"NRC Technical Assistance
for Design Reviews"
Contract No. NRC-02-85-002
FIN D1016

ITASCA DOCUMENT REVIEW

Document Title: "Site Characterization Plan, Chapter 2.0 — Geo-engineering (Controlled Draft 1) by the U. S. Department of Energy (January 26, 1987)

Fig. 1 Representative Volume for Rock Mass Strength Calculation

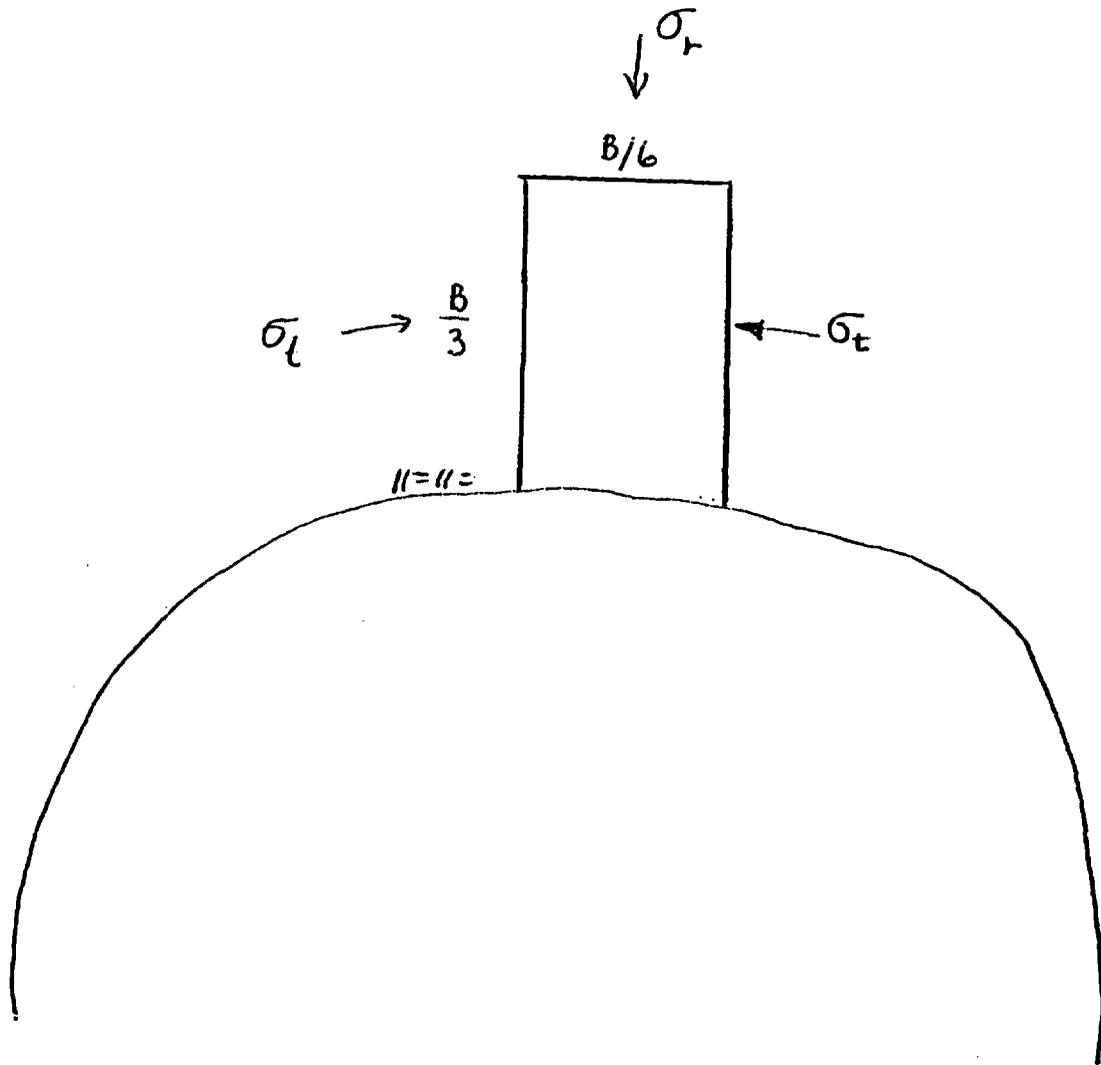
- D. Assume a representative volume or sample of rock in the peak of the emplacement drift with dimensions $B/3 \times B/6$ (see Fig. 1). Determine the average stress applied to the cube. Using the rock mass strength as determined from the Hoek and Brown criteria and reduced by the Rosengren and Jaeger and Hardy and Hocking approach, compare the stress to strength. Iterate until canister spacing produces a stress change which is less than the strength.

This simplistic approach has many problems. First, it apparently is used since no coupled thermal-mechanical analytical or numerical approach was available. The greatest limitation of this approach is the calculation of the thermally-induced stresses. The determination of an average temperature rise results in spatially-uniform stresses in the horizontal plane (the vertical plane is assumed unfixed). The result is to smear out stress gradients induced by thermal gradients around the heat source and, subsequently, to reduce the stress ratios. Additionally, the tensile stresses induced around the emplacement room due to thermal expansion are not accounted for. Therefore, the result is not conservative since peak stresses will be lower and tensile stresses will not be examined. Additionally, non-conservative field stresses are used as input.

Also, the stress concentration introduced by the emplacement hole (which is one-third the room height) is not added to the induced room stresses. This will result in significant additional stress concentrations around the room periphery.

Calculations presented in Itasca (1987b) for 1.6kw canisters for the BWIP geometry indicate that the most critical location for potential instability is the drift wall at the intersection of the emplacement borehole. Transient tensile stresses are induced in a vertical and horizontal direction which could result in slabbing or spalling of the walls of the drift. This could potentially impair the retrieval of the canister.

The point of this discussion is (1) that it is possible that the simplistic analysis presented does not examine the potentially worst failure mechanisms, and (2) that the stresses used apparently are non-conservative.
